SECTION 00905
ADDENDUM NO. 5

DATE:	June 1, 2016		
FROM:	FEI Engineers, Inc.	**PN/File**:	BENN-15-0176
TO:	ALL PLAN HOLDERS	**CC:**	D. Johnson, Public Works Director
SUBJECT:	ADDENDUM NO. 5 TO THE BIDDING DOCUMENTS FOR THE New Water Storage Tank Project Town of Bennett, Colorado

WATER STORAGE TANK PLAN & ELEVATION

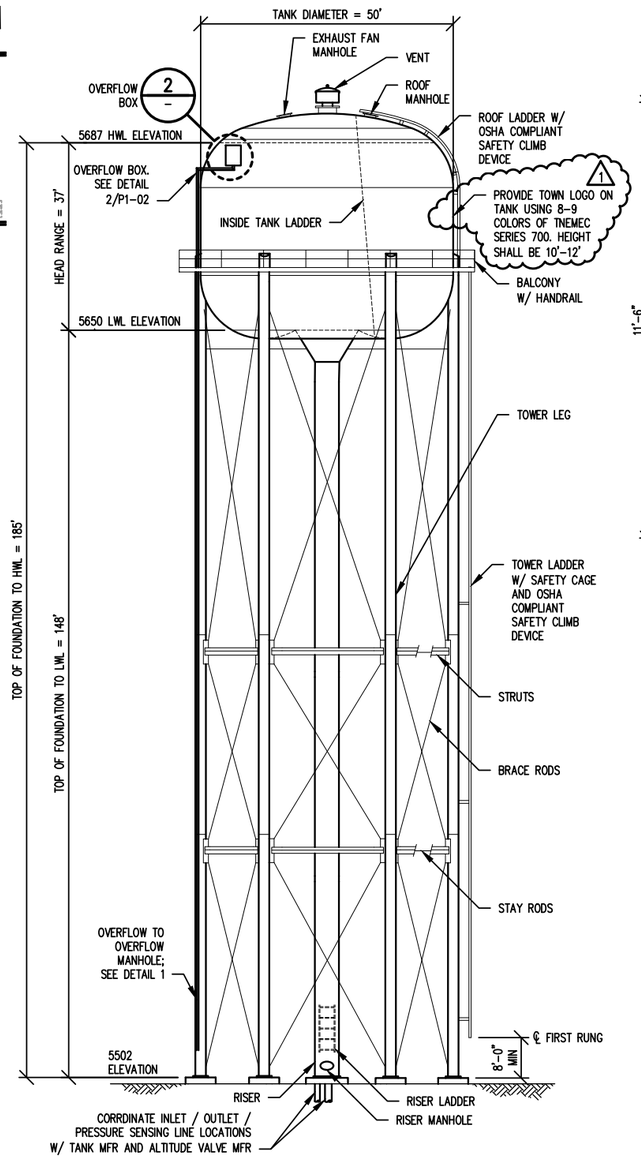
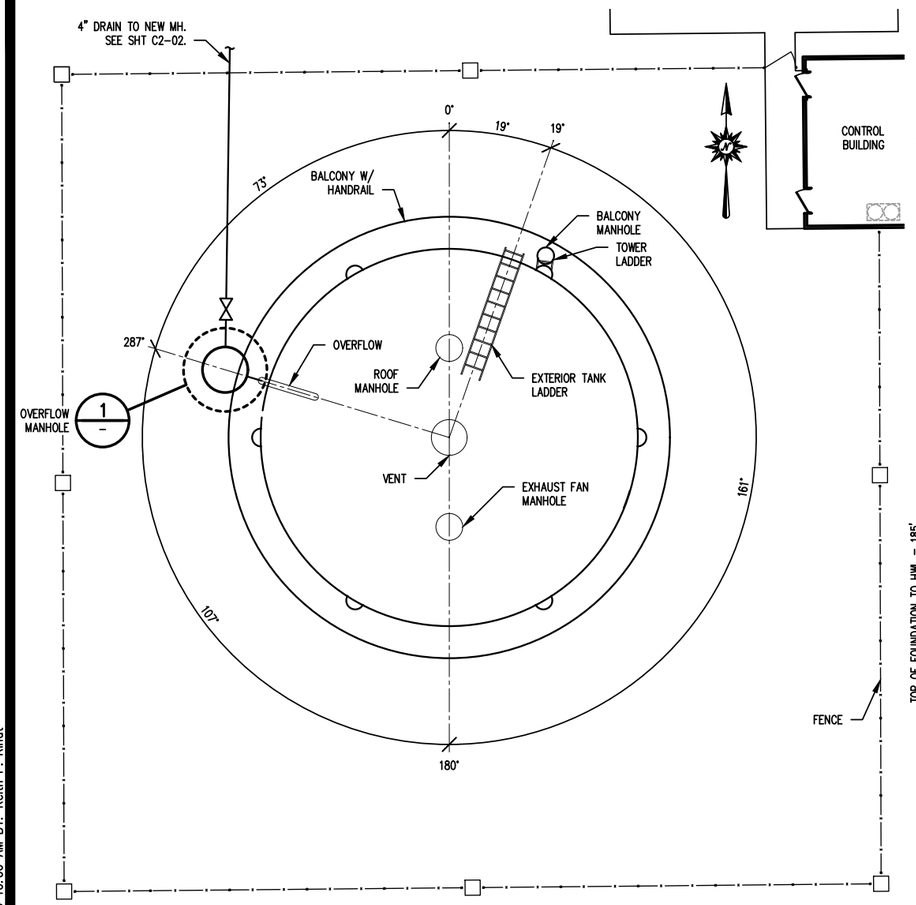
A. Sheet No. 34 of 44: Water Storage Tank Plan & Elevation
1. Added Town logo on tank
